# Life Textile Pvt. Ltd (Extension)

BSCIC Industrial Estate, Konabari, Gazipur  
(24.009262N, 90.322270E)

18-Sep-2023

# Observations

Sectional elevation of shed

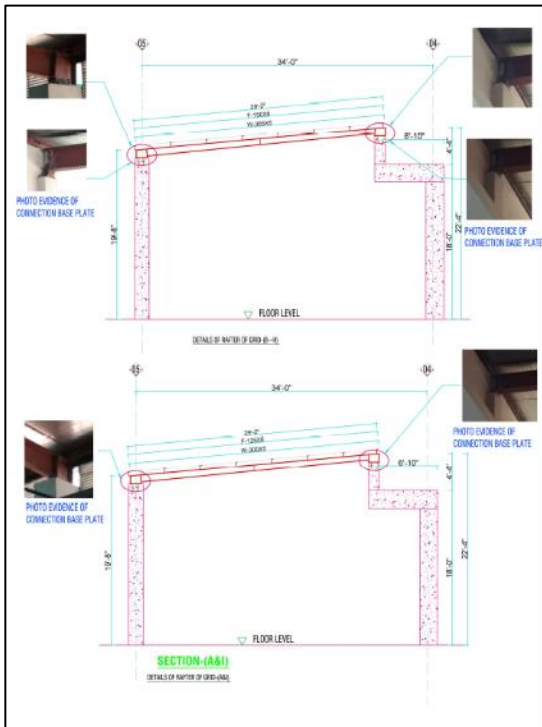
The steel shed is supported by the RC column of the knitting building. The connection between RC column & steel rafter is not clear. The shed does not have lateral load resisting system along the long direction. Factory engineer is required to perform Engineering Assessment (EA) to check the lateral stability & connection adequacy of the shed and prepare as-built drawing with connection details.

| Item No. | Observation                                                     | Recommended Action Plan                                                                                                  | Recommended Timeline |
|----------|-----------------------------------------------------------------|--------------------------------------------------------------------------------------------------------------------------|----------------------|
| 01       | Lack of lateral Stability of the steel shed (Knitting Building) | Building engineer is required to produce full set of as-built drawing including the actual connection details.           | 6-weeks              |
| 02       | Lack of lateral Stability of the steel shed (Knitting Building) | Factory engineer is required to perform Engineering Assessment (EA) to check the lateral stability & connection adequacy | 6-weeks              |

Knitting Building

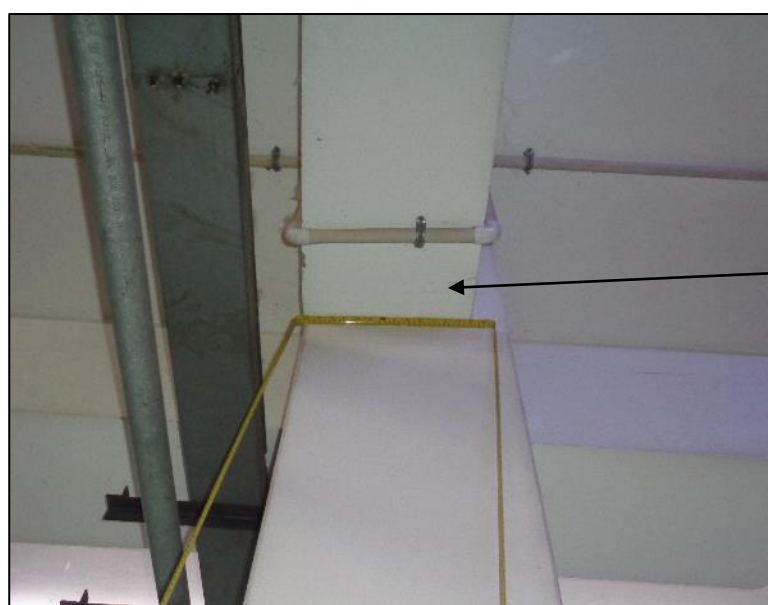
As per BNBC (part-6), every building or structure designed shall have its design documents prepared in accordance with the provision of Section 1.9.1. The design document shall include a design report, and a set of structural drawings, which shall be prepared in compliance with section 1.9.1.1 & section 1.9.1.2 of BNBC (part-6).

At the time of inspection, no design report was available. Building engineer is required to prepare a set of design documents in compliance with BNBC.

| Item No. | Observation                                                     | Recommended Action Plan                                                                                                  | Recommended Timeline |
|----------|-----------------------------------------------------------------|--------------------------------------------------------------------------------------------------------------------------|----------------------|
| 04       | Design report needs to be prepared (Knitting Building)          | Building engineer is required to prepare a design documents in compliance with section 1.9.1 of BNBC (part-6).           | 6-weeks              |

Beam Layout plan: beam width shown 375 mm

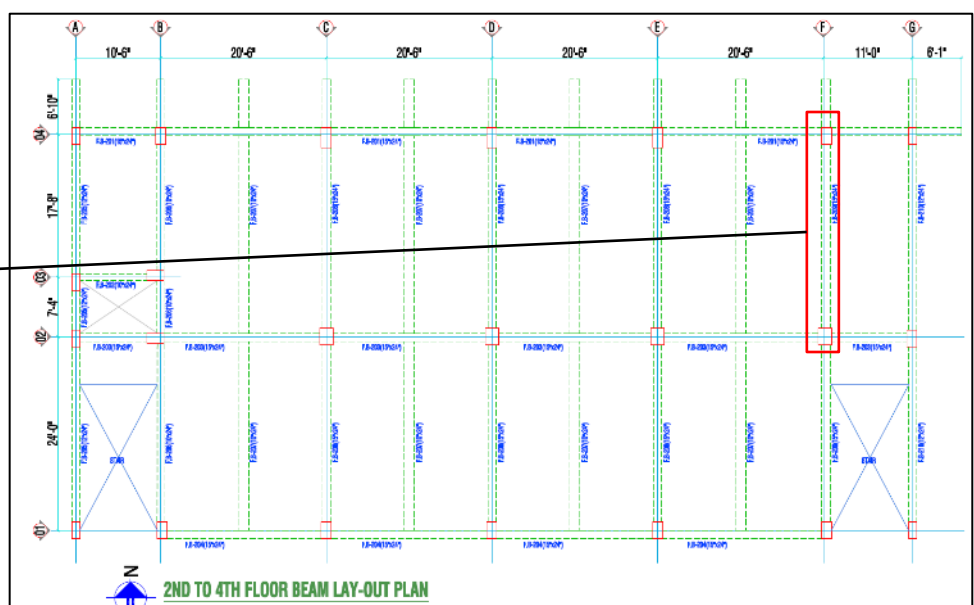
Beam width 300 mm onsite

Size of the beam width was found 300 mm instead of 375 mm.

Building engineer is required to survey the whole structure and update the as-built drawings and perform Engineering Assessment (EA)

False slab in toilet zone area

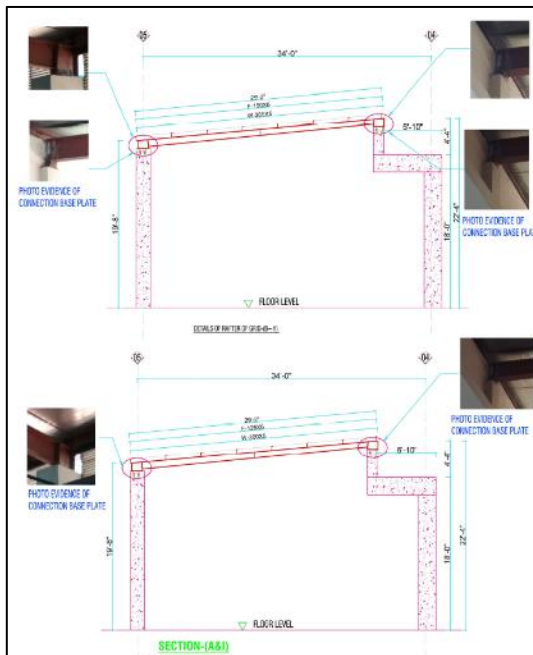
False slab was found in toilet zone area which was not shown in as-built architectural drawing.

Fire pump room below ground level

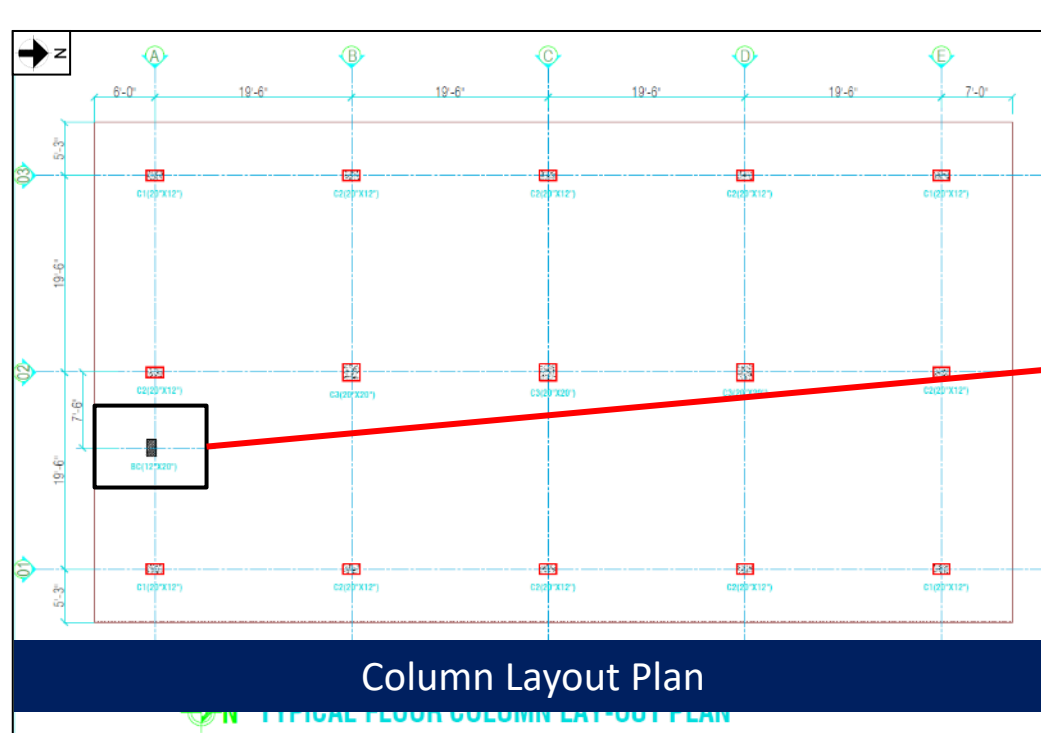
Fire pump room construed below ground floor level. But no structural details has been provided in as-built structural drawing.

Building engineer is required to survey the whole structure and update the as-built drawings and perform Engineering Assessment (EA).

Stone chips Aggregate in column

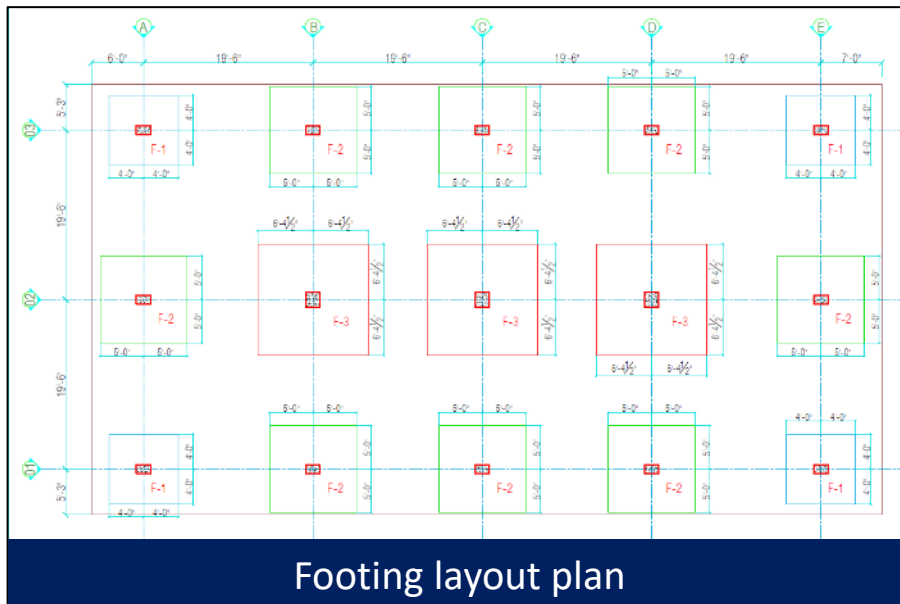
Stone chips aggregate found in column instead of brick chips aggregate.

Building engineer is required to survey the whole structure and update the as-built drawings.

Retrofitting column layout and schedule

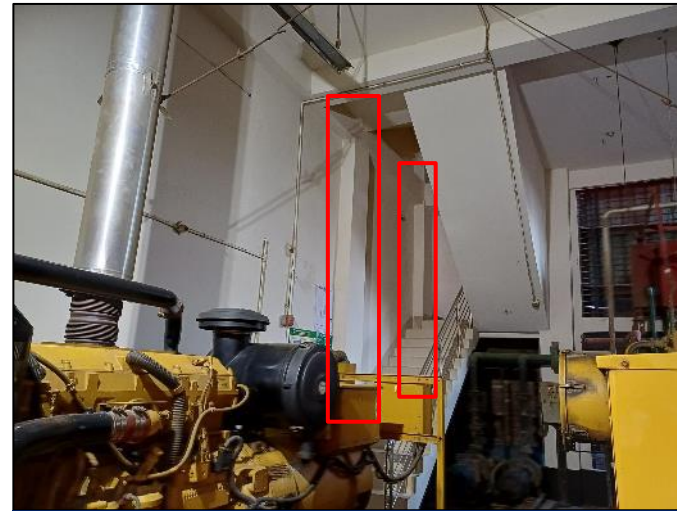
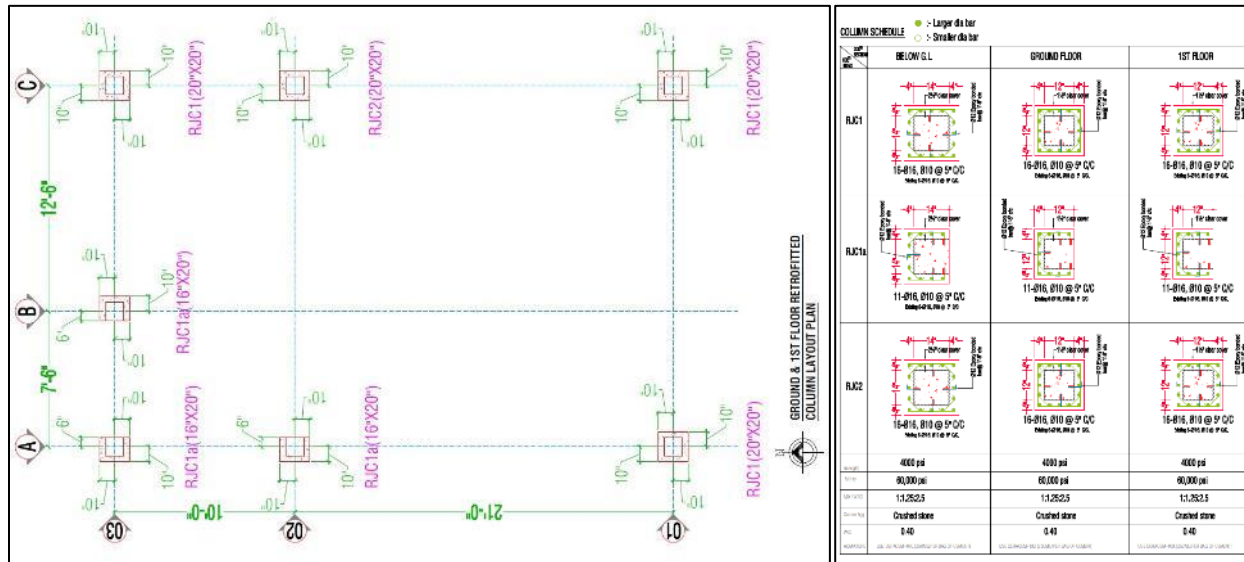
Column has been retrofitted for the generator building. Building engineer is required to submit the Detail Engineering Assessment (DEA) documents to the RSC for the further review to justify the capacity of foundation, column and beam & slab against the lateral & vertical loading.

| Item No. | Observation                                                      | Recommended Action Plan                                                                                                                                                                                 | Recommended Timeline |
|----------|------------------------------------------------------------------|---------------------------------------------------------------------------------------------------------------------------------------------------------------------------------------------------------|----------------------|
| 14       | Retrofitting documents needs to be reviewed (Generator Building) | Building engineer is required to submit the Detail Engineering Assessment (DEA) documents to RSC for the further review to justify the capacity of column and foundation for lateral & gravity loading. | 6-weeks              |
